**RELEASED FOR  
 FABRICATION / INSTALLATION**  
 PPPL Drafting:

Oak Ridge National Laboratory managed for the DEPARTMENT OF ENERGY under U.S. GOVERNMENT contract DE-AC05-00OR22725 UT-BATTELLE, LLC, Oak Ridge, Tennessee PROJECT NAME						
NATIONAL COMPACT STELLERATOR EXPERIMENT VACUUM VESSEL PERIOD INSPECTION AND LEAK CHECK ASSEMBLY						
VERSION NO.	PLANT	BLDG	FL	SHT OF	TYPE	CLASS
5	X-10	5700	3	2 19	A	U
RELEASE LEVEL		SE120-004			REV	
Fabrication					2

SECTION H-H  
SCALE 0.09

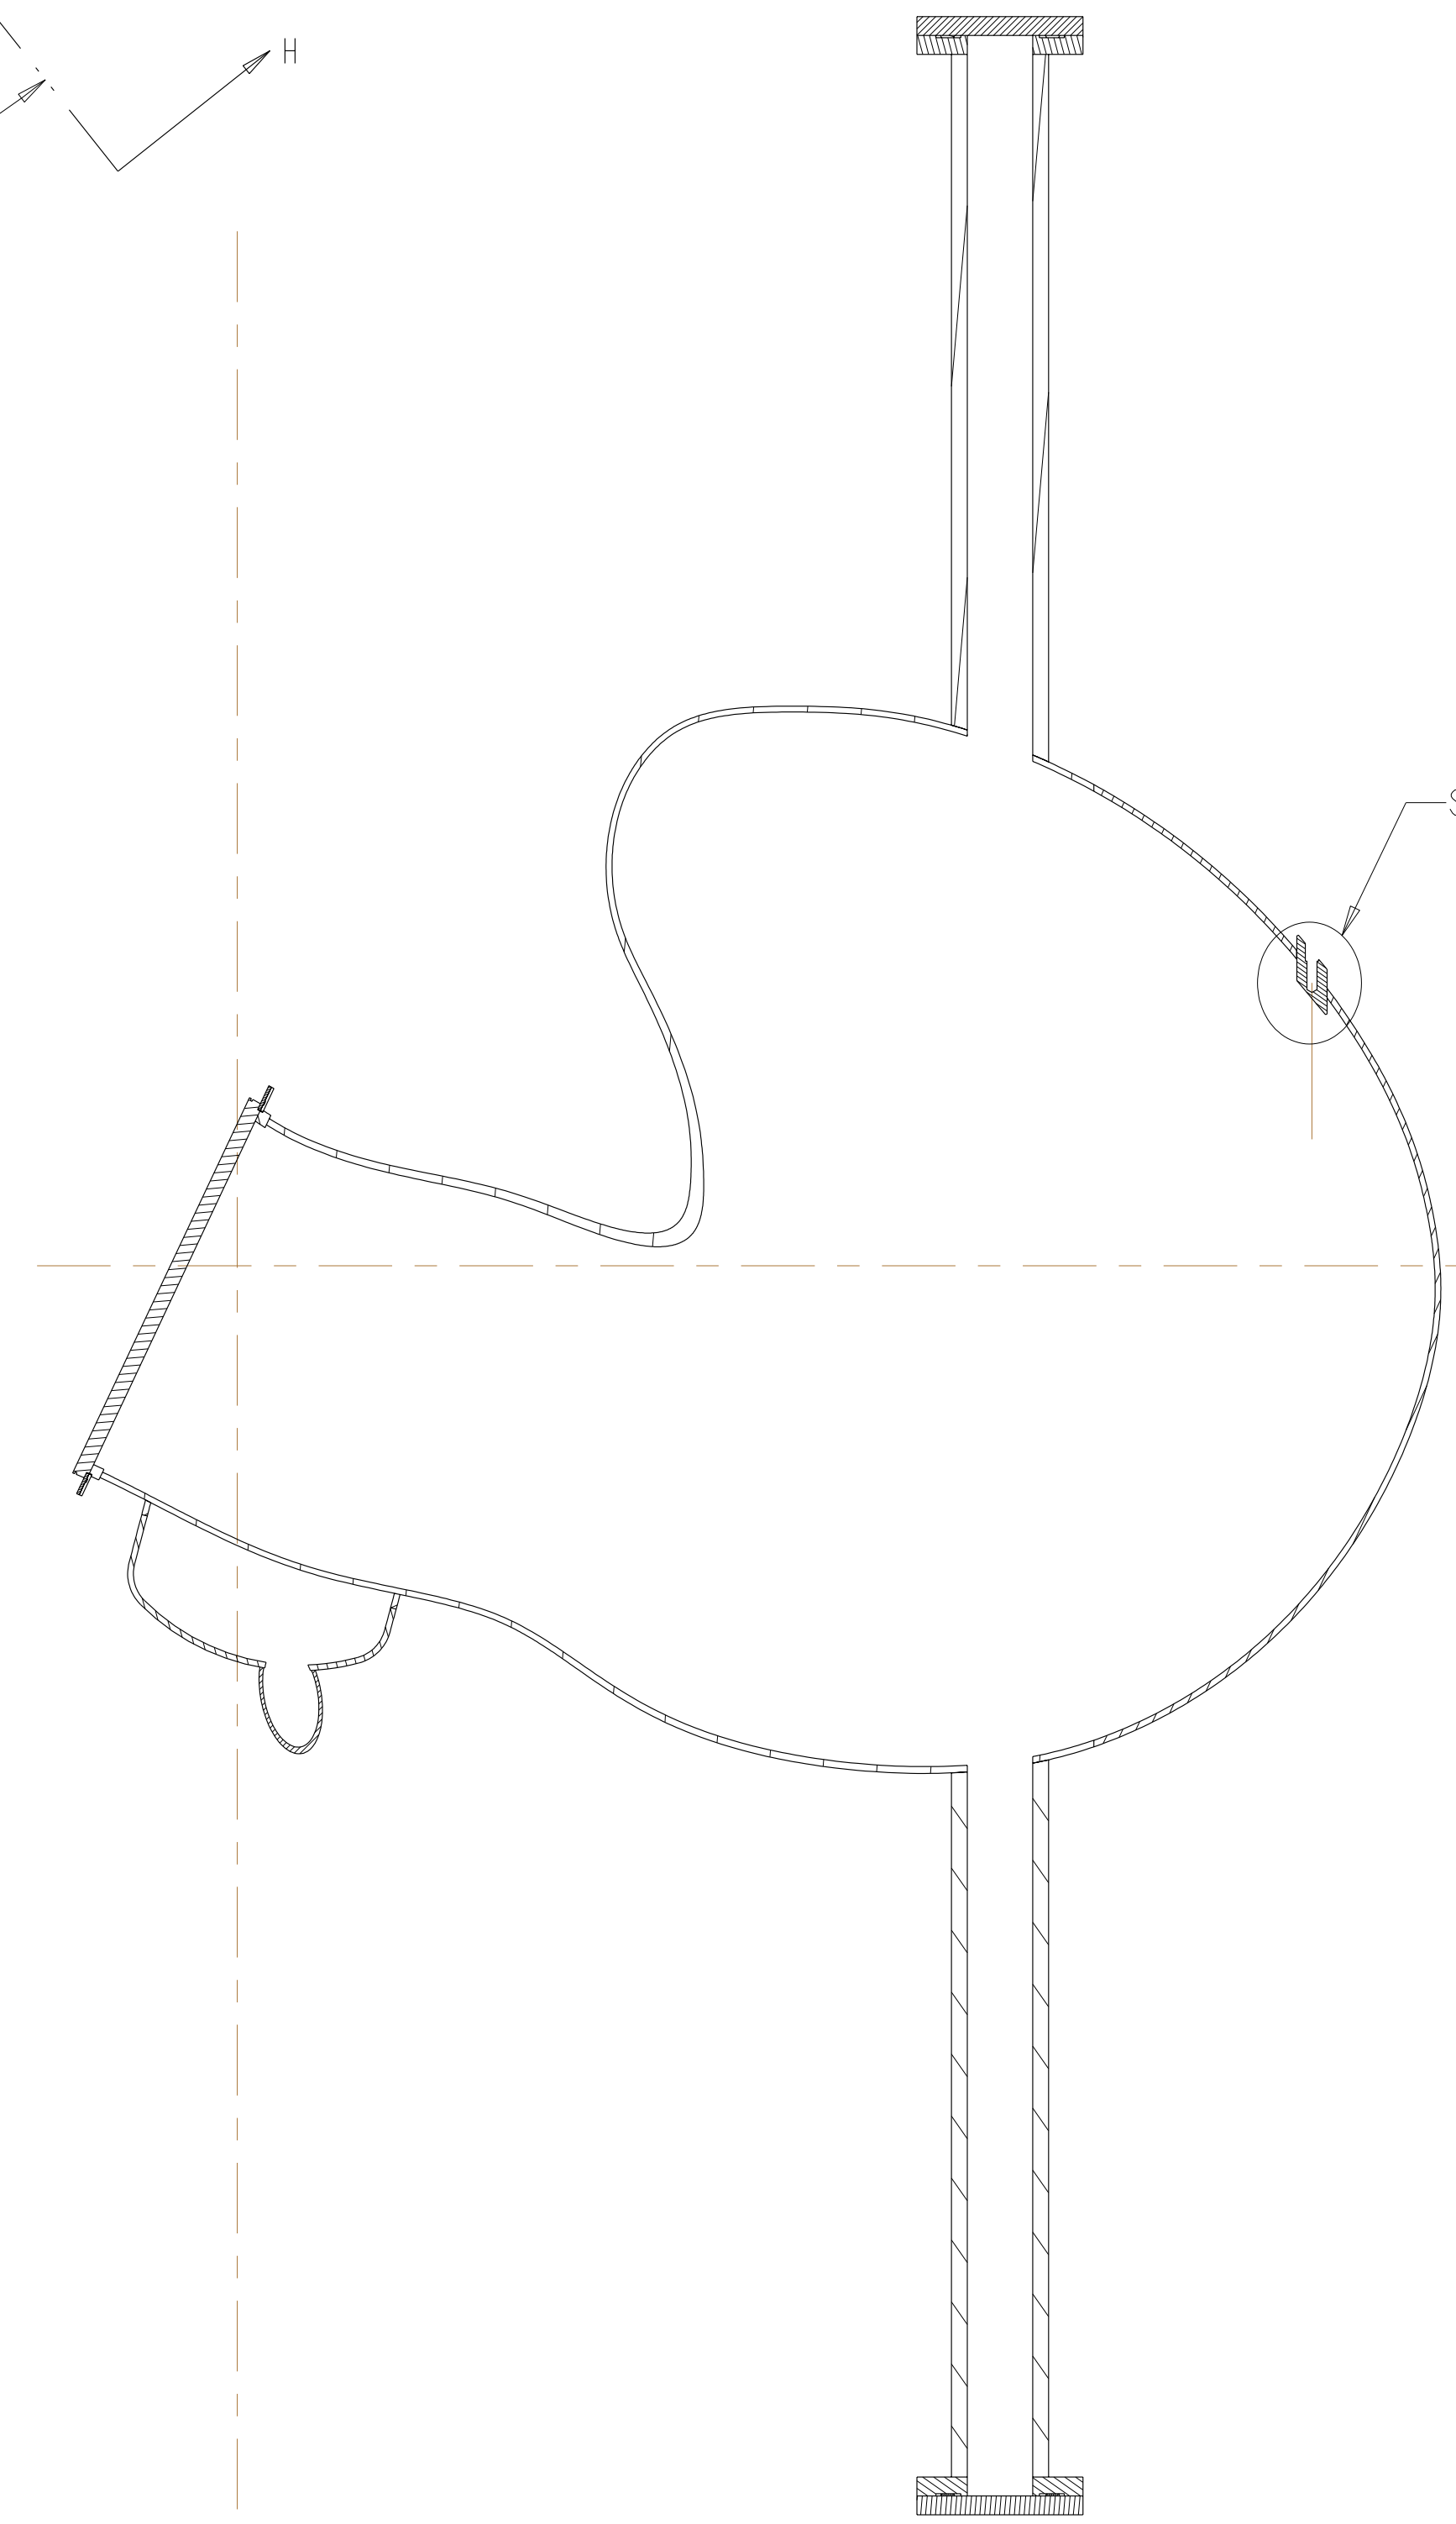
**ECN-5082.** Requirement originally included grooves to facilitate leak checking by vendor. However, vendor elected another means of leak checking and therefore the grooves are no longer required. Specifically, this ECN eliminated the leak checking groove on SE121-014 (Rev 1-c) and SE1221-091 (Rev 0-a). Additionally, this ECN added a missing weld symbol to SE121-004 (Sheets 4 through 19) for joining the port extensions to the vessel (Rev 2-d).  
**(See ECN-5082 for details)**

**Rev 2-e: ECN-5021 (RFD-12-017) approved alternate methods for welding the port extensions to the VVSA (See ECN-5021 for details). - Only applicable to VVSA #3 - VVSA #1 and #2 covered by NCR 19464.**
